City of Tualatin

SUBDIVISION REVIEW FINDINGS AND DECISION FOR SB 15-01, MISSION TERRACE

This staff report recommends approval of a 13-lot and 2-tract plan for the Mission Terrace Subdivision, as shown on plans dated February 17, 2015 attached as Exhibit A with conditions of approval as outlined in the staff report.

MISSION TERRACE
TUALATIN, OR
PRELIMINARY SITE PLAN

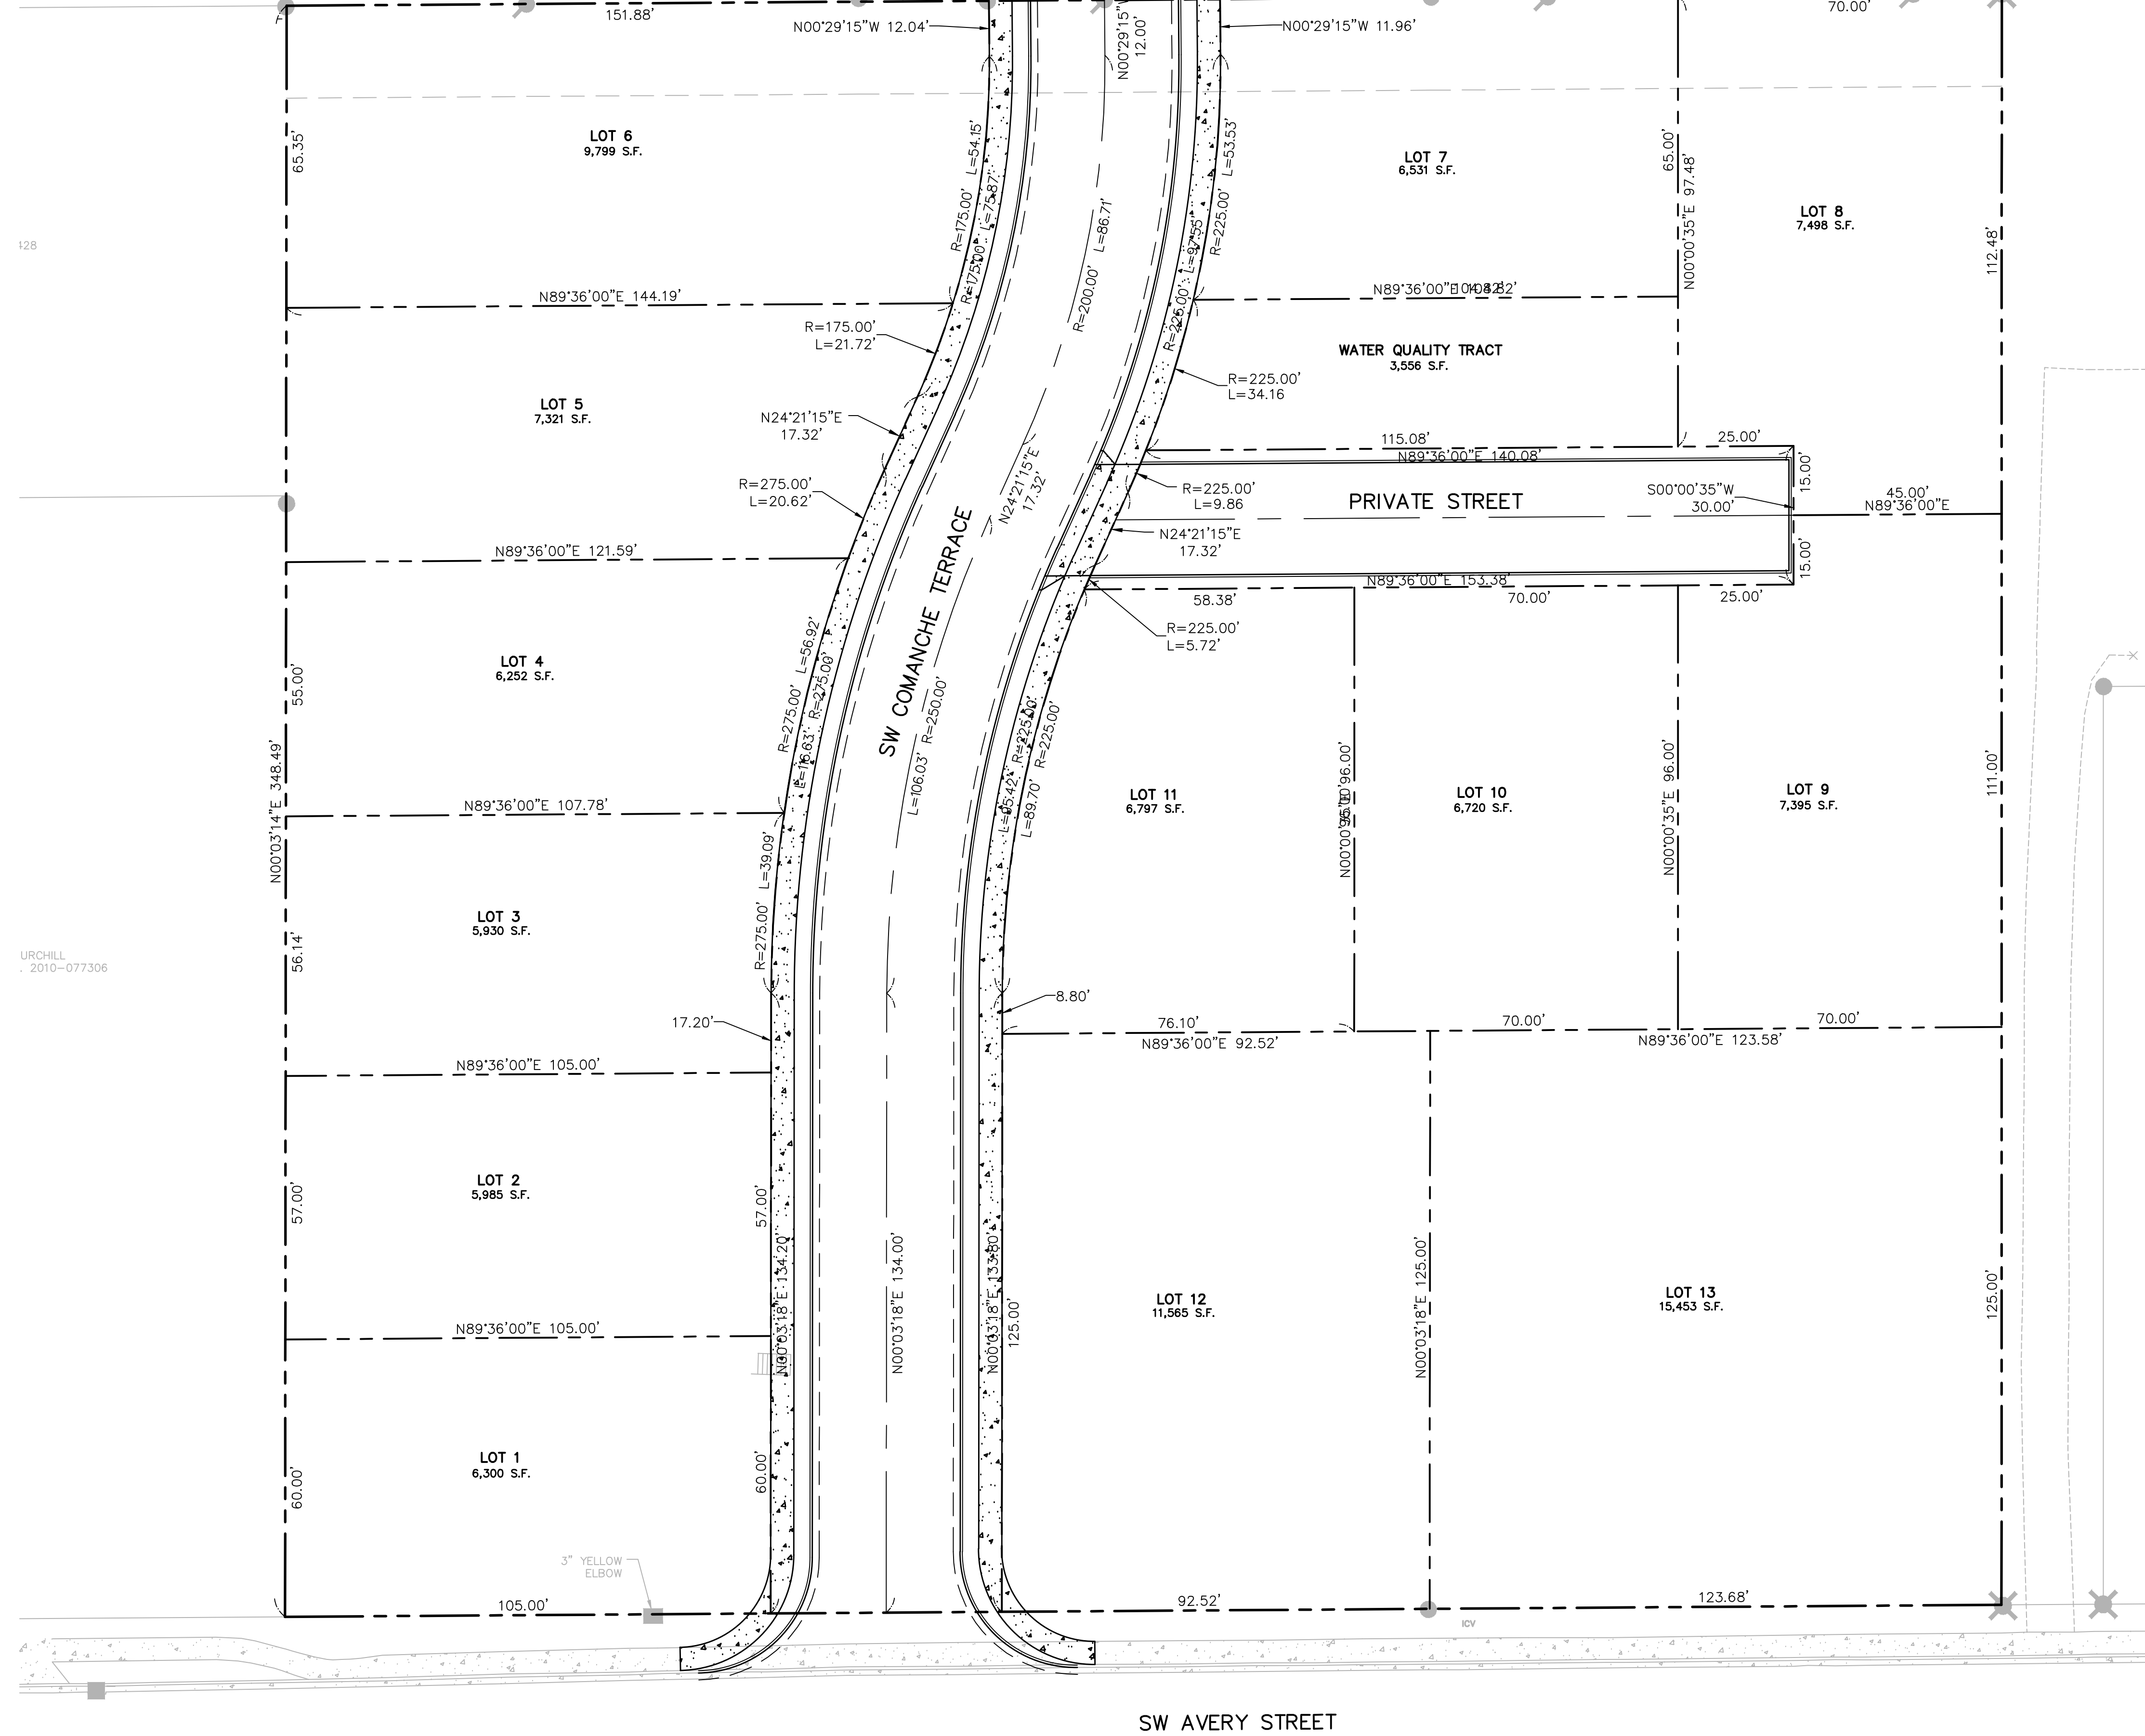
The plans do not show accesses from lots 1 to 11. Access for lots 1 to 11 will need to be either to SW Comanche Terrace or to Tract A, the private street. The minimum access width is 10 feet and the maximum widths are 26 feet for a one or two car garage and 37 for a 3 or more car garage. The applicant will need to submit plans that show accesses for lots 1 to 11 to SW Comanche Terrace or Tract A with a minimum of 10-foot wide and a maximum of 26 feet wide for one or two car garages and 37-foot wide for three or more car garages, for review and approval.

The plans show accesses for lots 12 and 13 to SW Avery Street. SW Avery Street is classified as a Minor Collector with access spacing restrictions. There are two existing accesses for lot 13 with the eastern access shown to be closed. The City Engineer has interpreted the remaining accesses to be acceptable in this circumstance. The applicant will need to submit final plans that show the existing accesses for lots 12 and 13 to SW Avery Street with the eastern access on lot 13 to be closed, for review and approval.

The plans do not show an approach for maintenance vehicles to the water quality facility. An approach is needed sufficient for a 50,000 pound vehicle to clean the outlets. The applicant will need to submit revised plans that show a 15-foot wide driveway approach with a 16-foot wide gate for the public water quality facility, for review and approval

No fence is shown surrounding Tract B, the water quality facility. A fence is needed for safety and security. The applicant will need to submit revised plans that show a fence surrounding Tract B, for review and approval.

- *The applicant shall submit plans that show accesses for lots 1 to 11 to SW Comanche Terrace or Tract A with a minimum of 10-feet wide and a maximum of 26 feet wide for one or two car garages and 37-feet wide for three or more car garages, for review and approval.*
- *The applicant shall submit final plans that show the existing accesses for lots 12 and 13 to SW Avery Street with the eastern access on lot 13 to be closed, for review and approval.*

- *The applicant shall submit revised plans that show a 15-foot wide driveway approach, fence, and 16-foot wide gate for the public water quality facility, for review and approval.*

- *The applicant shall submit revised plans that show a fence surrounding Tract B, for review and approval.*

PRELIMINARY UTILITY PLAN

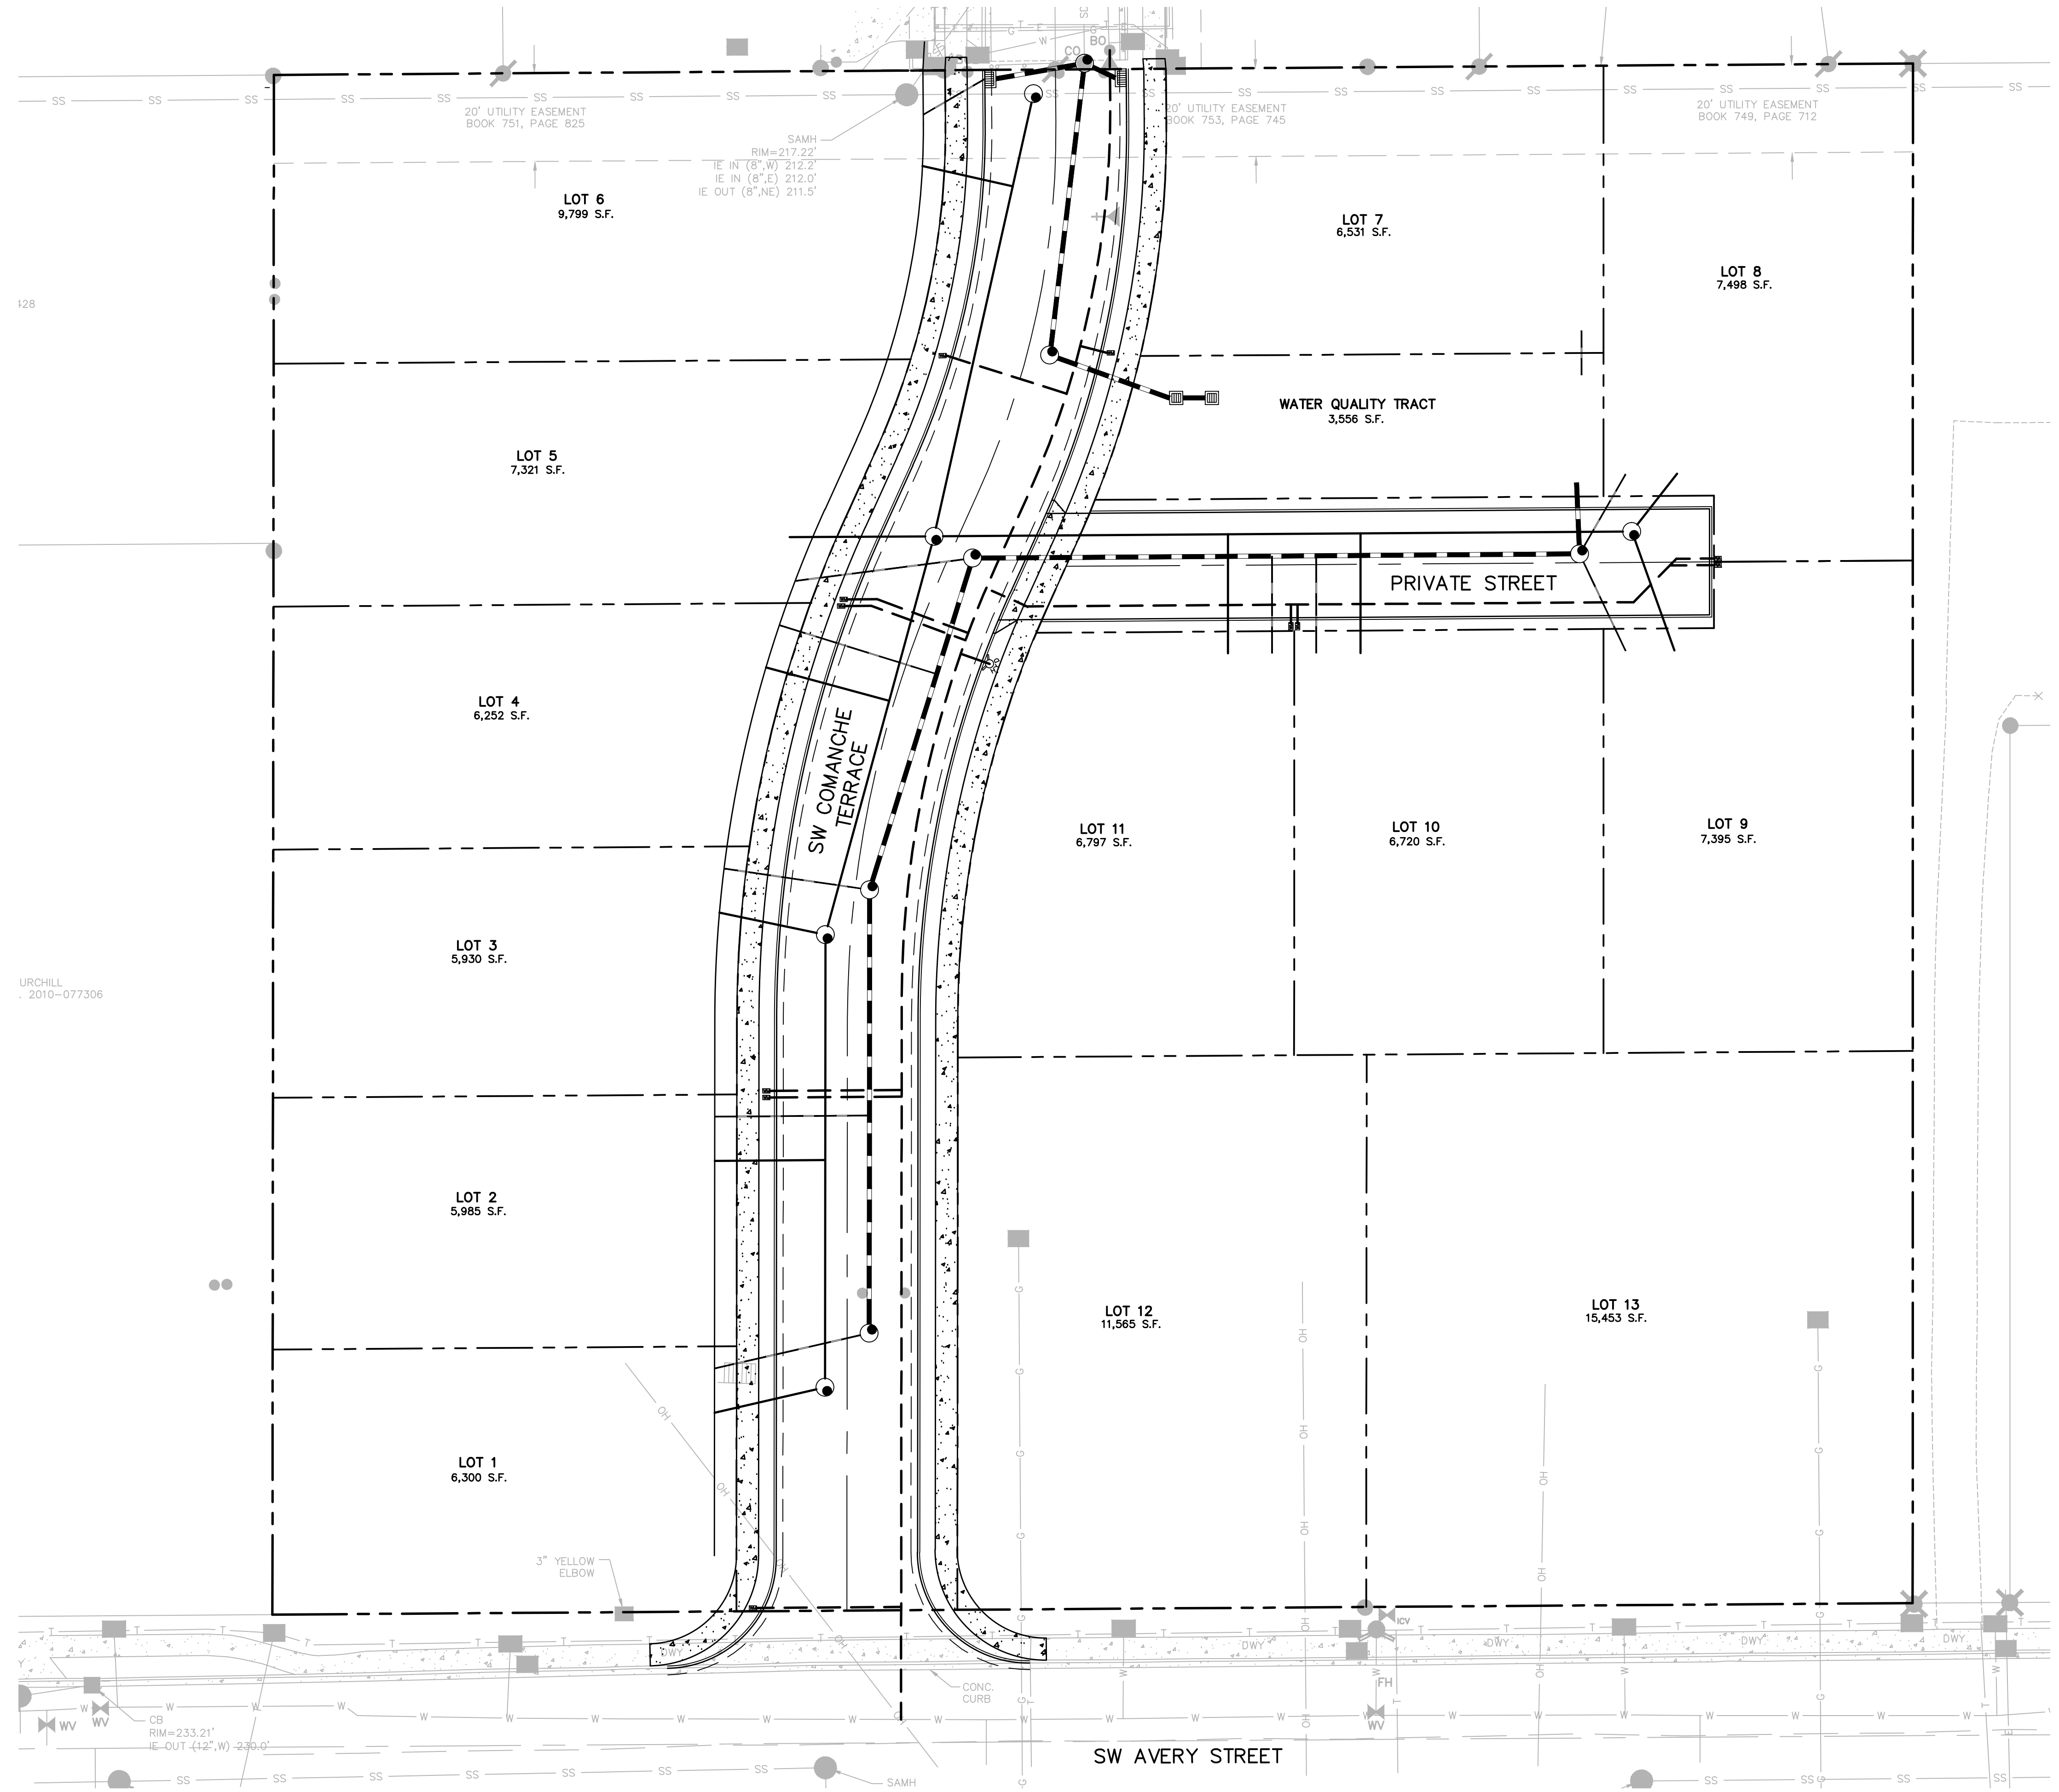
The plans show a proposed public water line extending from an existing line in SW Comanche Terrace connecting to an existing public water line within SW Avery Street to the south with laterals serving lots 2 to 7 and the water quality facility Tract B. Lots 1, 12, and 13 are served by existing laterals and meters connecting to a public water line in SW Avery Street. This is acceptable.

A public water line is shown to extend from the future line in SW Comanche Terrace to the east within the private street Tract A with laterals serving and meters adjacent to lots 8 to 11. A public water line is not needed within Tract A as water laterals can be within a private easement and the meters will need to be installed adjacent to SW Comanche Terrace, the public street. The applicant will need to submit revised plans that show water meters for 8 to 11 within SW Comanche Terrace right-of-way with a private water easement within the private street Tract A for laterals, for review and approval.

The plans show the public sanitary sewer line extended from an existing line in SW Comanche Terrace towards SW Avery Street to serve lots 1 to 7. A public sanitary sewer line is shown extending east within Tract A, the private street, within a public sanitary sewer easement to serve lots 8 to 11. No service is shown for lots 12 or 13. An existing public sanitary sewer line is shown in a 20-foot wide public sanitary sewer easement adjacent to the north property line of the existing lots. Three existing laterals serve the existing lots that will either need to be capped at the main line or reused to serve lots 6 to 8. A public sanitary sewer line will need to be located to enable lots 12 and 13 to have laterals with direct access to the public easement. The applicant will need to submit revised plans that include sanitary sewer laterals for lots 12 and 13 directly connecting to a public sanitary sewer line, for review and approval. The applicant will need to submit revised plans that show a 15-foot wide sanitary sewer easement over portions of new public sanitary sewer lines outside of right-of-way, for review and approval. The applicant will need to submit a 15-foot public sanitary sewer easement over portions of new public sanitary sewer lines outside of right-of-way, for review and approval.

With development, extension of the public sanitary sewer system is needed to serve adjacent properties as needed. Both properties to the east and west have capacity to be divided and would need access to public sanitary sewer systems. The applicant will need to show on revised plans extension of public sanitary sewer lines within 15-foot wide public easements to the properties to the east and west or show that they have sufficient access to public sanitary sewer systems with future redevelopment, for review and approval. The applicant will need to submit 15-foot wide public sanitary sewer easements for any public sanitary sewer lines on private property, for review and approval.

- *The applicant shall submit revised plans that show water meters for 8 to 11 within SW Comanche Terrace right-of-way with a private water easement within the private street Tract A for laterals, for review and approval.*
- *If needed, the applicant will need to install double check valve assemblies to meet the requirements of TMC 3-3.120(4).*

- *The applicant shall submit revised plans that include sanitary sewer laterals for lots 12 and 13 directly connecting to a public sanitary sewer line, for review and approval.*
- *The applicant shall submit revised plans that show a 15-foot wide sanitary sewer easement over portions of new public sanitary sewer lines outside of right-of-way, for review and approval.*
- *The applicant shall show on revised plans extension of public sanitary sewer lines within 15-foot wide public easements to the properties to the east and west or show that they have sufficient access to public sanitary sewer systems with future redevelopment, for review and approval.*

ARBORIST LEGEND

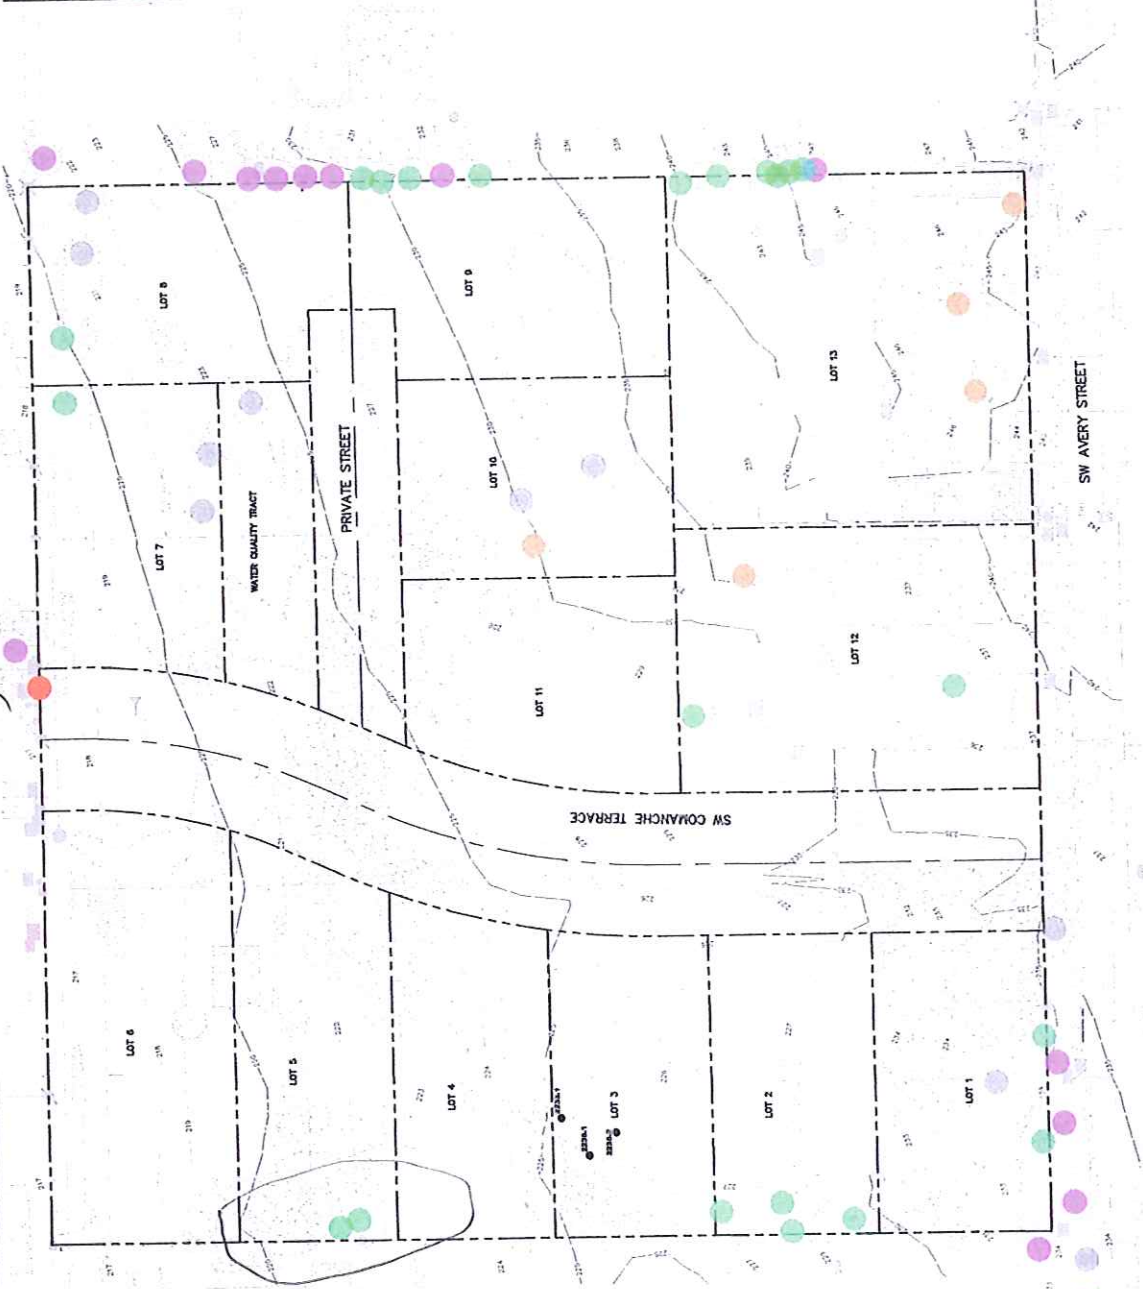
We have some concerns about the tree removal and the impact of the water drainage. Attached is a copy of the arborist legend for the trees. Lot five shows two trees to be retained. The trees are a part of a stand of Douglas Firs. As stated in your response to Section 34.230 Criteria, "As noted by the arborist's report, because the large trees on the site have grown up as members of dense stands, individual trees will become subject to windthrow hazard if exposed by removal of neighboring trees". Please include the removal of the trees, coded in green, on lot 5.

Please remove Thank You

In regard to your concern of two particular trees on Lot 5 (tree 2197 & 2198, Douglas firs), we will add them to the trees to be removed. As you observed on our plan, a number of other trees in close proximity to these two trees will also be removed during site work construction.
